| project                             | drawing                       | date          |
|-------------------------------------|-------------------------------|---------------|
| PLOT 4 LLYS BARAN, RHYDYFRO S4B 4RW | FLOOR PLANS & ELEVATIONS      | DECEMBER 2021 |
| MR MARTIN EVANS                     | 21.LBR.06b                    | 1   50 @ A1   |

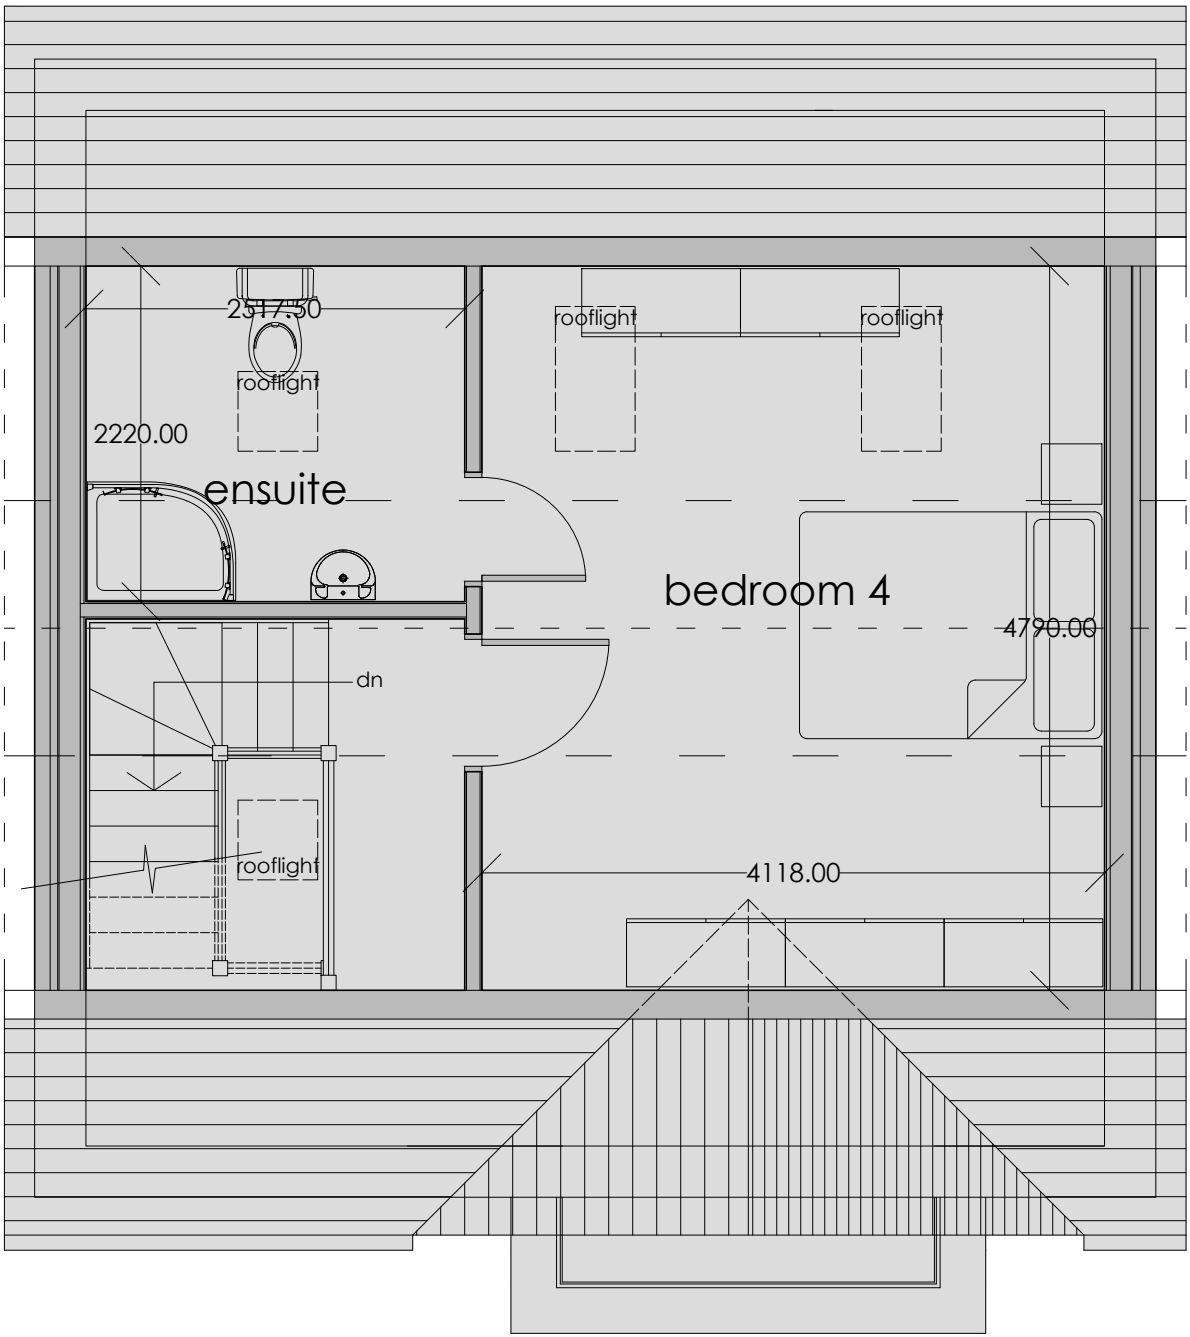
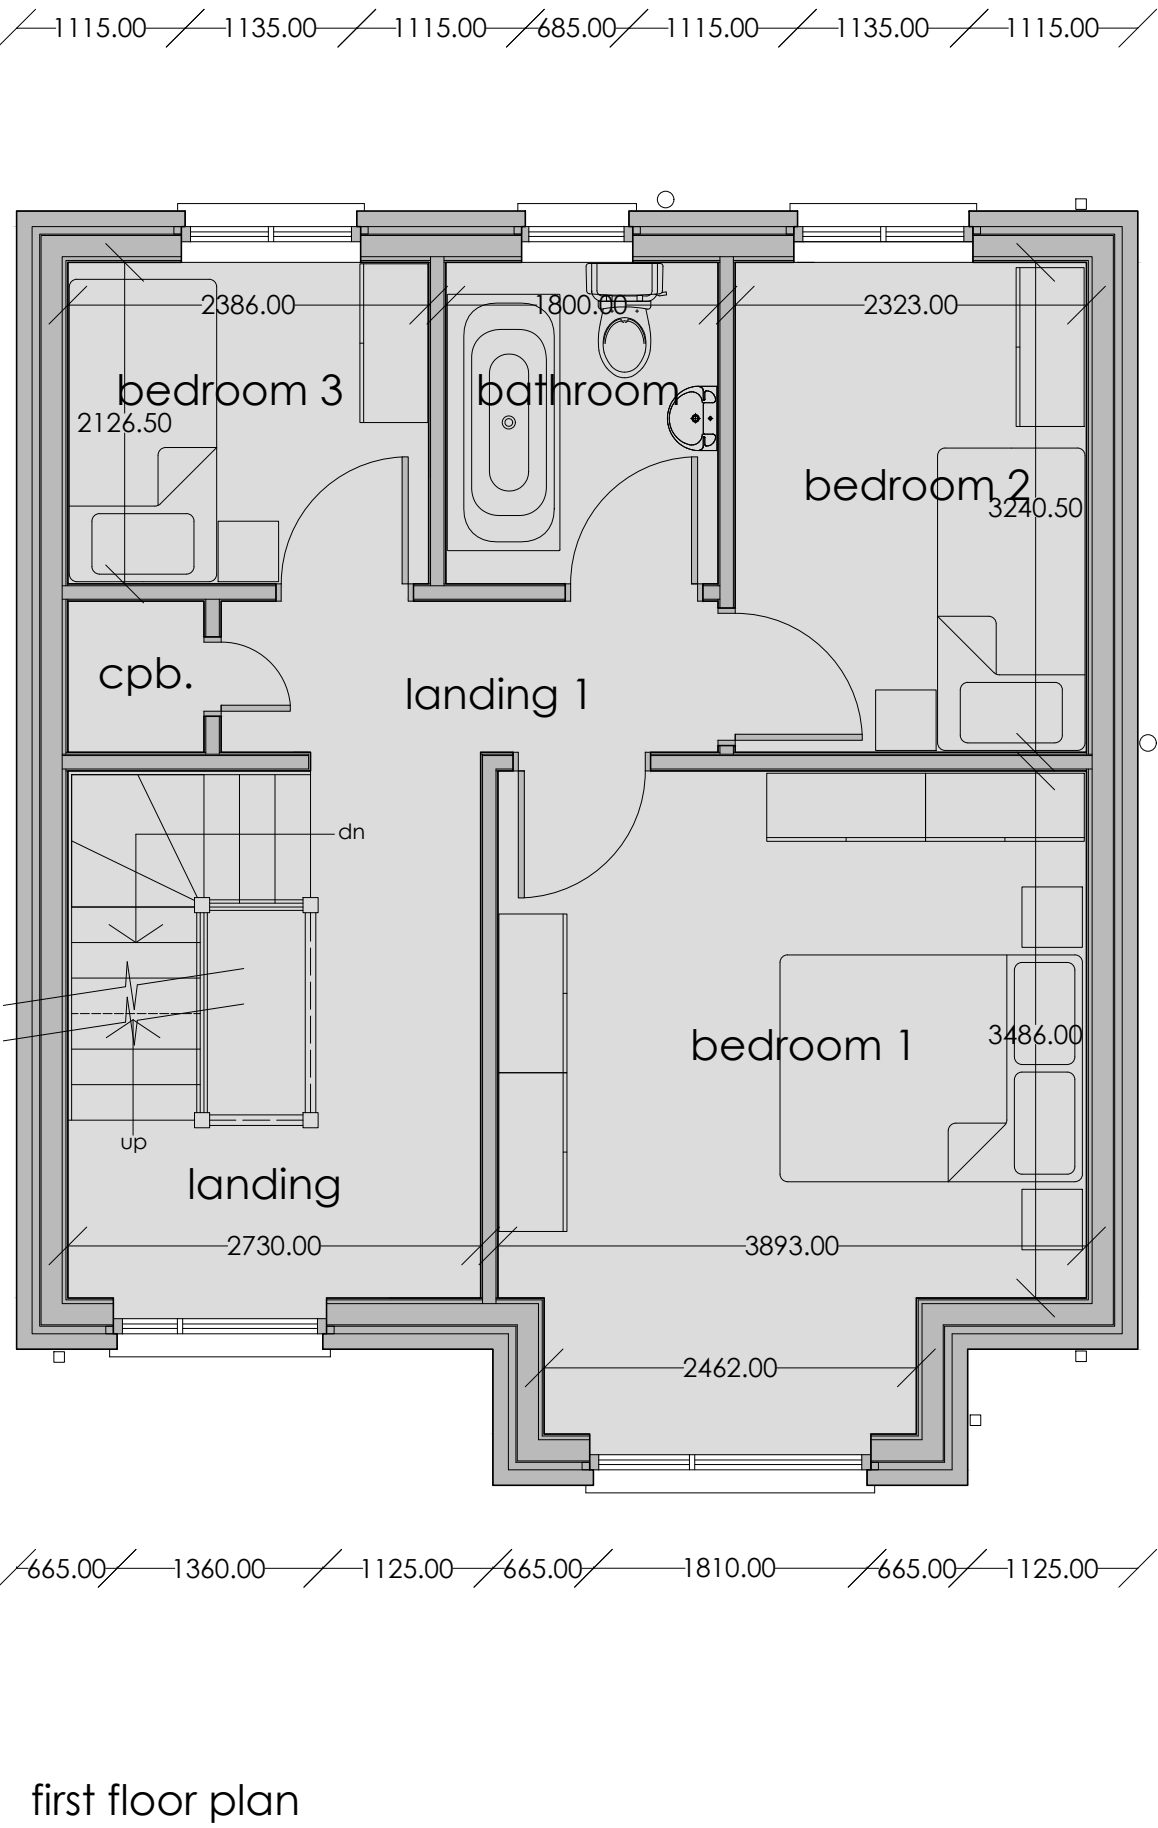
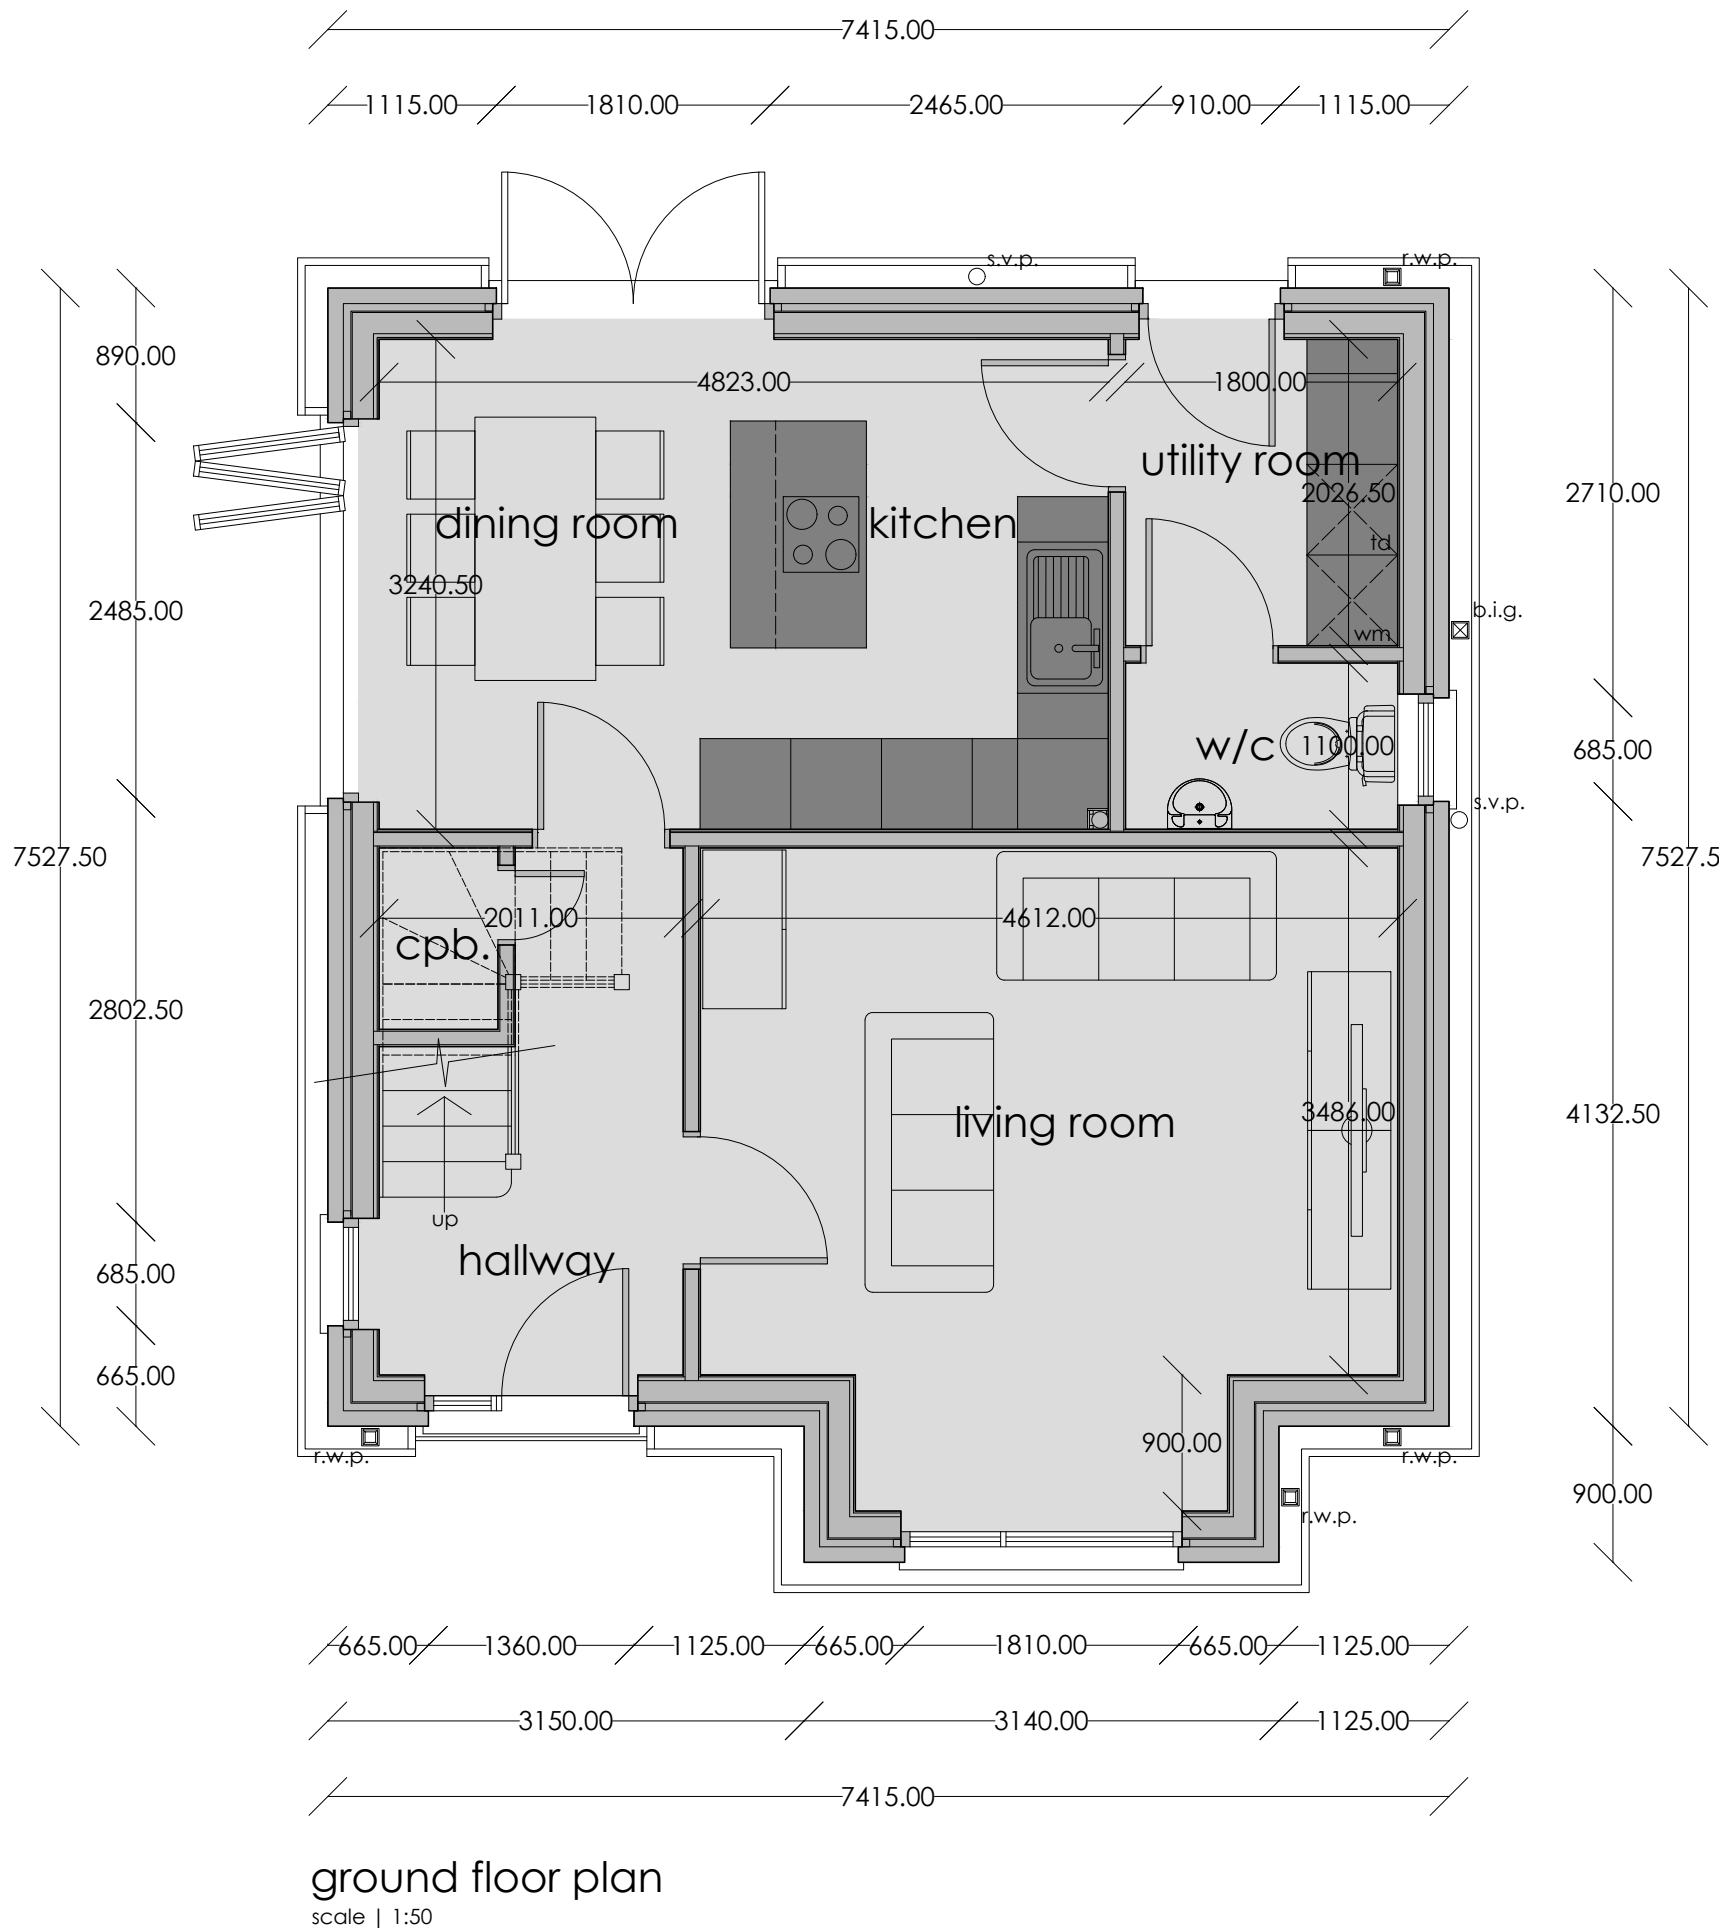
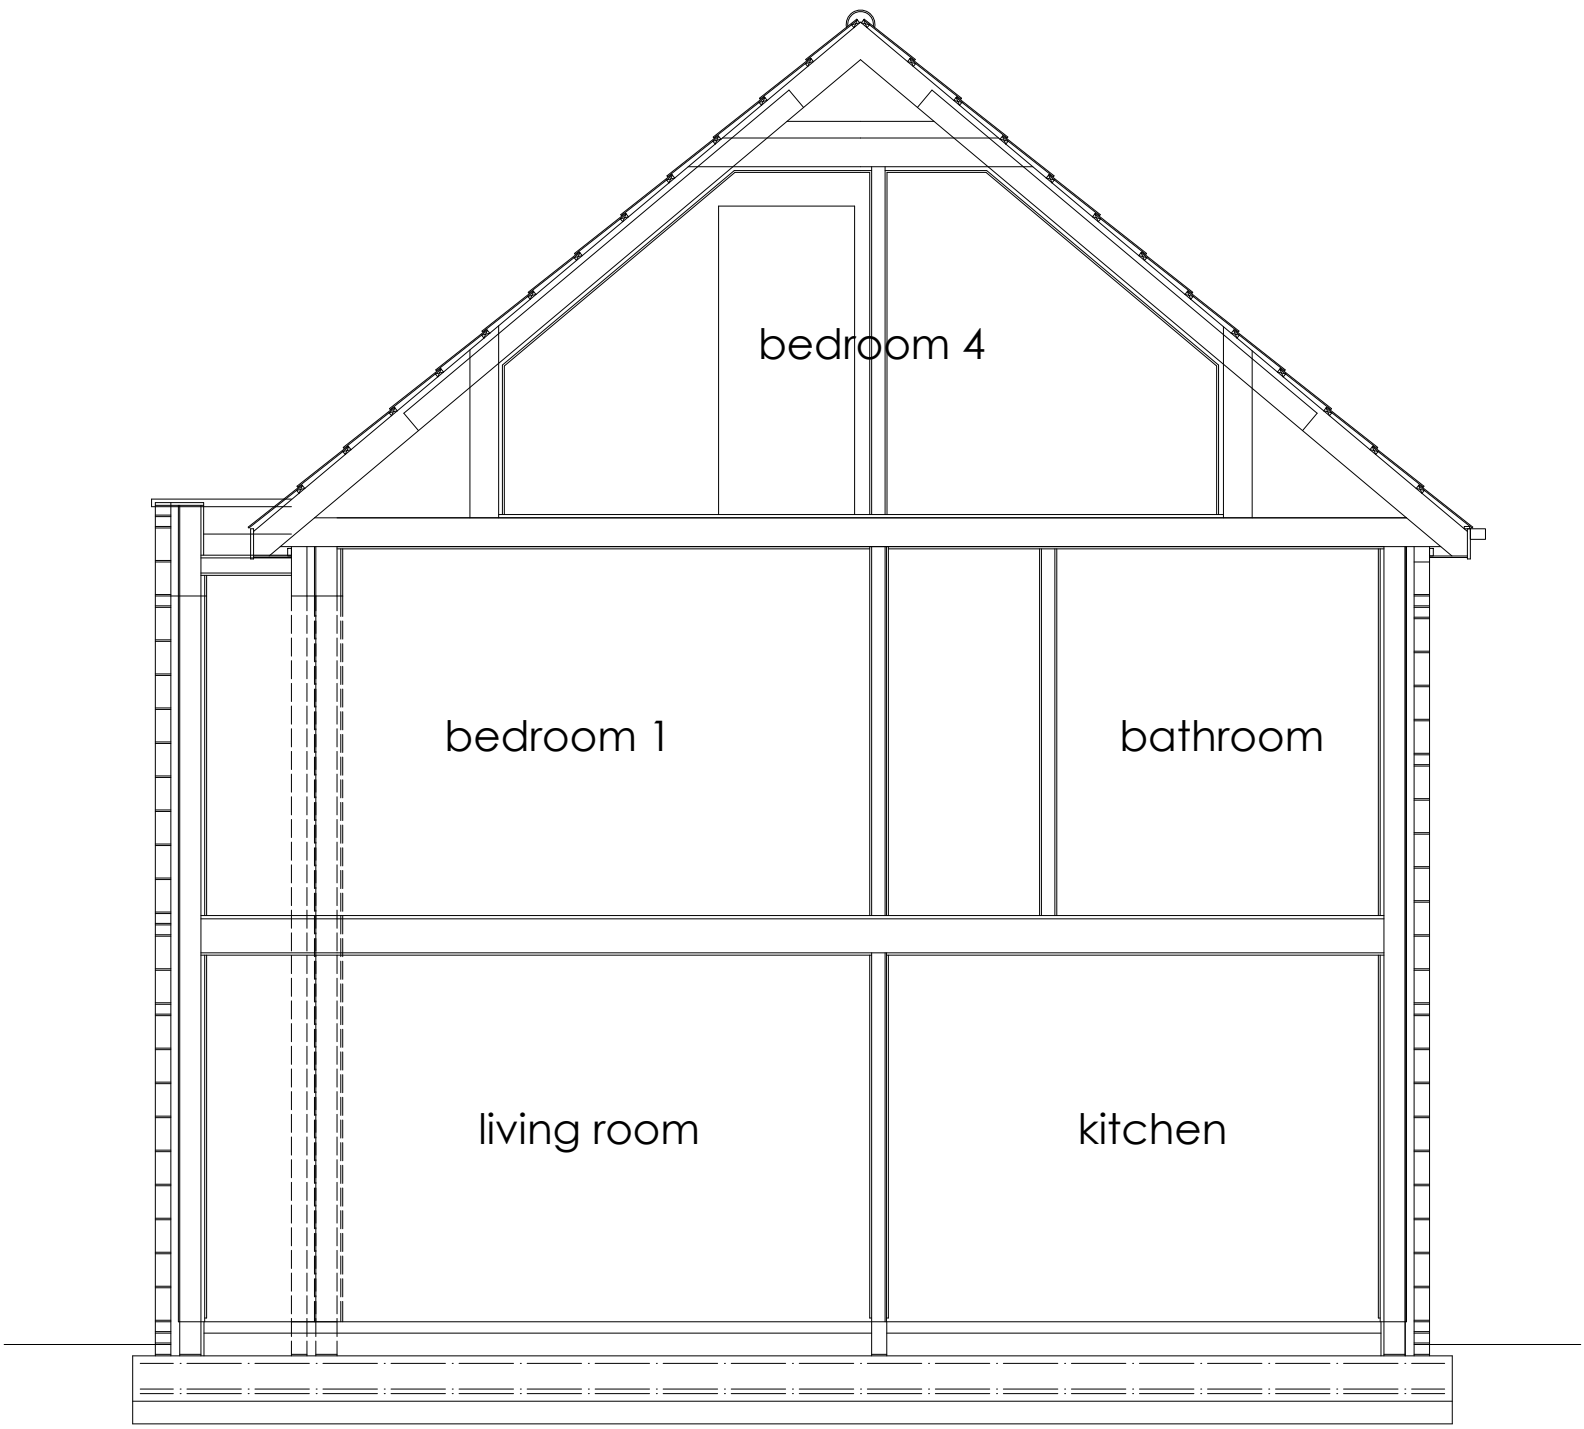
| revision |                                                                                                  |
|----------|--------------------------------------------------------------------------------------------------|
| a        | bio-diversity enhancements added (bat box) to north elevation at the request of the lpa_08.08.22 |
| b        | bat box annotated to north elevation at the request of the lpa_15.08.2022                        |
